**SOUTH JORDAN CITY
PLANNING COMMISSION REPORT**

Issue: **ACCESSORY BUILDING:
CONDITIONAL USE PERMIT FOR THE ARCHITECTURAL STANDARDS OF
ACCESSORY BUILDINGS IN R-1.8 ZONE**

File No.: PLCUP202400128
Property Address: 9557 S. 3770 W.
Applicant: Leon Bryant Widdison
Property Owner: Leon Bryant Widdison
Submitted By: Andrew McDonald, Planner II

① FRONT ELEVATION - SOUTH
SCALE: 1/4" = 1'-0"

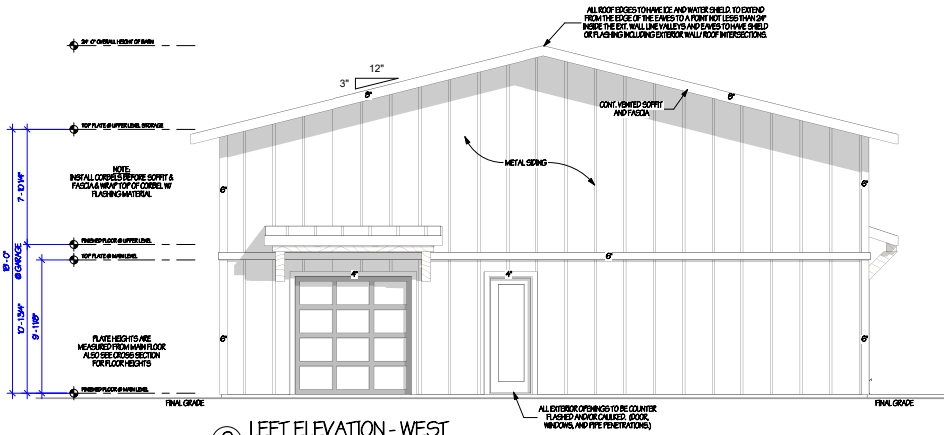
- Access to the building will use existing lot frontage along 3770 West, a private road.
- The property line follows the center line of 3770 West.
- There will be no business use of this building. The property owner does not intend to have living space (see supporting materials).
- Accessory buildings are common to the neighborhood. The applicant has provided examples of neighborhood garages that compare to the building proposed (see the letter from applicant).
- There are larger homes in the area that would be able to construct the proposed building without needing a CUP.
- The building exceeds the minimum setback requirements.
- The garage has a second-story storage loft, and a below grade basement. Both are intended for storage of personal items.
- The existing home has an overall height of just over 25'. The overall height of the garage is proposed to be 24'.

- The roof pitch meets the minimum requirements of the R-1.8 Zone.
- The average wall height meets the requirements of the R-1.8 Zone.
- The building will be constructed from foundations up, instead of using pre-fabricated, pre-assembled metal materials.

FOOTAGES

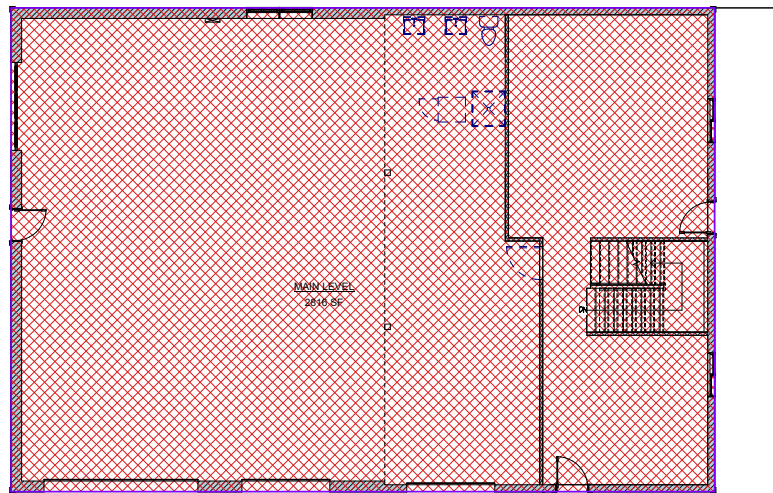
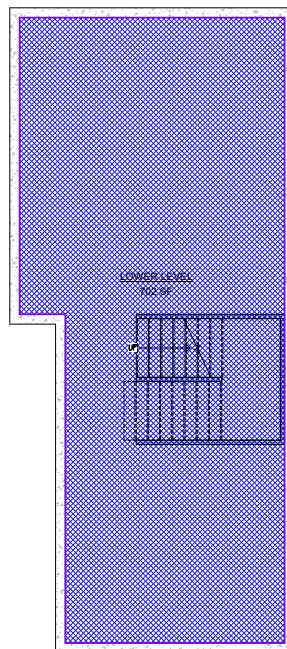
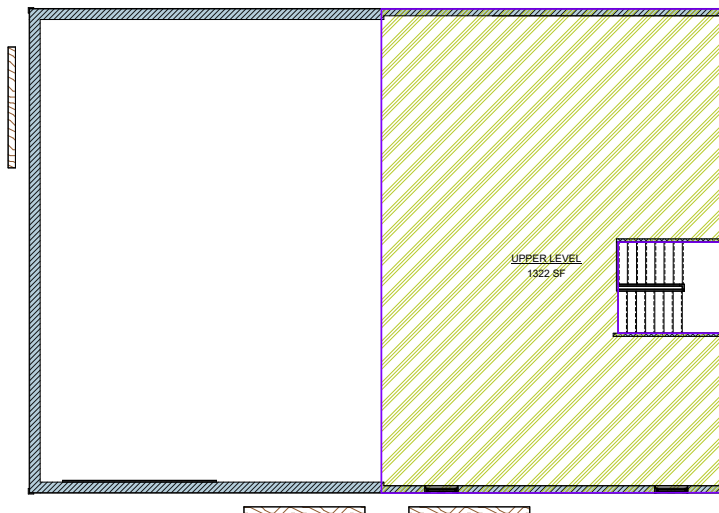
- The footprint of accessory structures in the R-1.8 Zone must be equal to or less than the footprint of the main building (including attached garages). The footprint of the existing building (including the attached garage) is 1,448 ft². The overall footprint of the proposed building exceeds the main footprint by roughly 1,368 ft², and thus requires a conditional use permit.

Examples of Similar Buildings in area

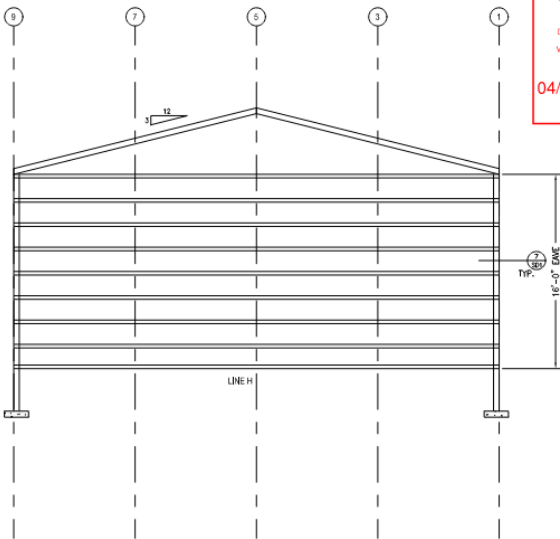
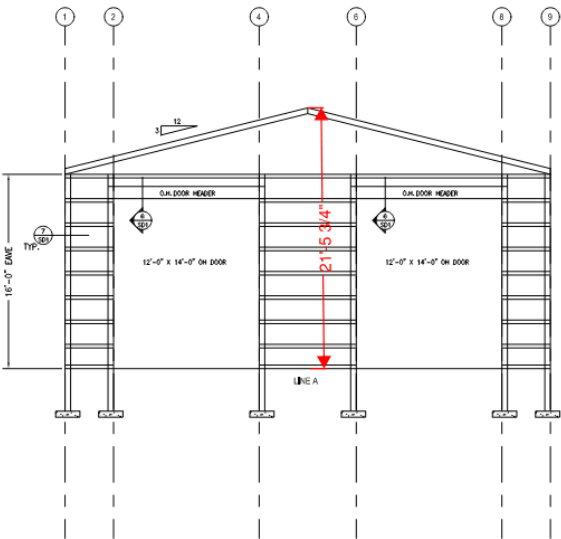
The applicant includes in the application that "many homes in my neighborhood have detached garages and there are several that have buildings that are similar in size". The proposed building is almost twice the size of the home. Staff has reviewed the area, and cannot find any properties with detached garages that are as large as what is being proposed. Please provide the addresses or location of the properties that you are referring to so that Staff may include them in review to better understand your proposal, and its compatible and consistent with the character of the surrounding area?

9588 S. 3770 W.

Home Size: 3,066 sf.

Garage Size: 2,244 sf. (34' x 66')

Building Permit issued 2004.

9558 S. 3770 W.

Home: 2,268 sf.

Garage: 2,400 sf. (40' x 60'),
Building Permit issued 1988
